LRD Opinion Response (Planning Reference No: LRD9004/26-S2)

Proposed Residential Development at Beaumont Road /
Beaumont Grove / Grace Park Court / Ellenfield Road, Beaumont,
Dublin 9

September 2026

This Report sets out the civil engineering responses which are required in respect of the engineering related items from the opinion. This submission is made on behalf of the applicant, Urban Life (BMD) Ltd.

Figure 2 - Catchment 1

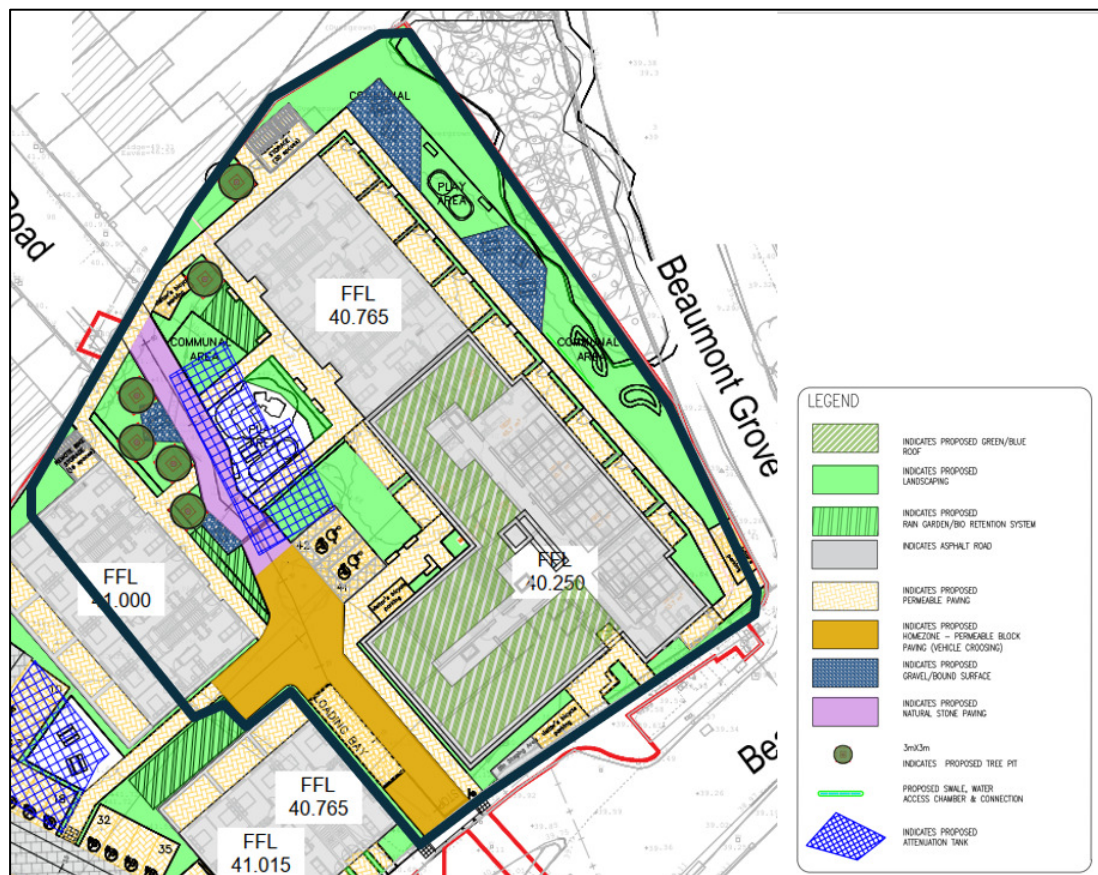
- A more detailed sub-catchment layout should be provided, which indicates clearly how each area within the site is to be drained.*
- If the stone attenuation areas are designed to infiltrate, then groundwater levels need to be confirmed. There should be sufficient depth of unsaturated soil between the bottom of infiltration devices and top groundwater level.*

Catchment 01 is represented in more details at the image below:

For this catchment, as can be seen in figure 2 above, most of the pavement proposed is to be permeable or otherwise draining into rain gardens and/or ground level bioretention systems. The proposed flat roof of the apartment building will be 100% a blue roof, to intercept and store water. The water from the roof will be restricted at roof level to an allowable flow of 0.40 l/s (in reference to the Greenfield Run off) and will connect directly into the tank from an inspection chamber as shown

in Waterman Moylan Drawing No. 20-048-P2200 – Proposed Drainage Layout. 50% of this roof will also be an intensive green roof to enhance the biodiversity elements of the site. A number of tree pits are proposed, which will intercept and direct excess water to the drainage network or directly to the rain gardens. The main attenuation and storage features for the catchment are the proposed underground stone attenuation tank, located under the main plaza central area. This tank will be lined, and all outfall water will be restricted by means of a hydrobrake set to greenfield run off as set above.

PROPOSED WORKS ON PUBLIC SPACE

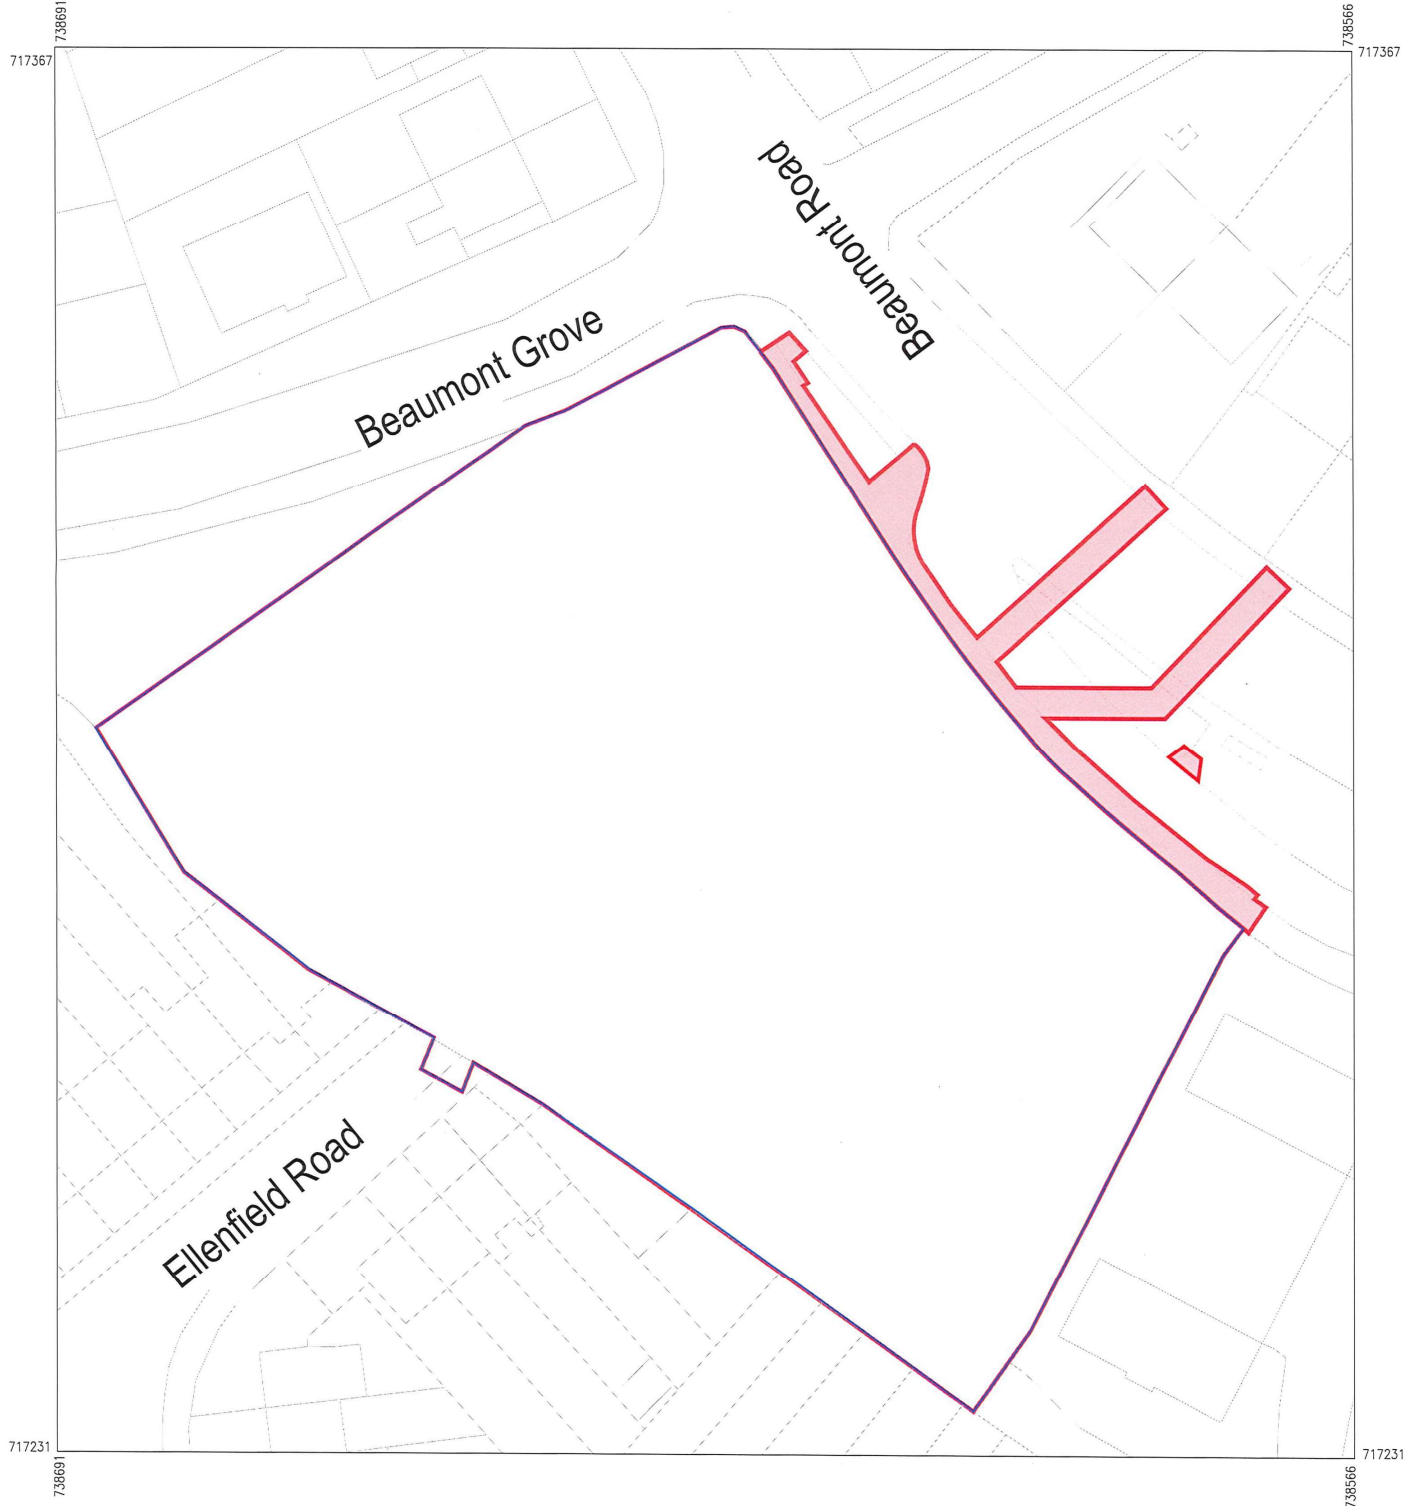
A Letter of Consent to extend the redline boundary into the public road will be required. The applicant is requested to liaise with and seek agreement on proposed changes from the Transportation Planning Division prior to submission of the application with regard to the Letter of Consent and show the intention of a pedestrian crossing along the slip road off Beaumont Road as per the recommendation of the RSA.

We have engaged with Dublin City Council to seek agreement on the red line into the public road. Please refer to Waterman Moylan Drawing 20-048-P2000-Proposed Works on Public Space for the approved red line extents. See attached letter of consent received from Dublin City Council at Appendix B of this report.

I refer to the above intended planning application, the site of which includes lands in the control of Dublin City Council, specifically lands within the roadway and footpath (as indicated hatched on attached drawing No. 20-048-P2000 – Proposed Works on Public Space).

I wish to confirm that the City Council has no objection to the inclusion of these lands for the purpose of making a planning application. This is without prejudice to the outcome of the planning application process.
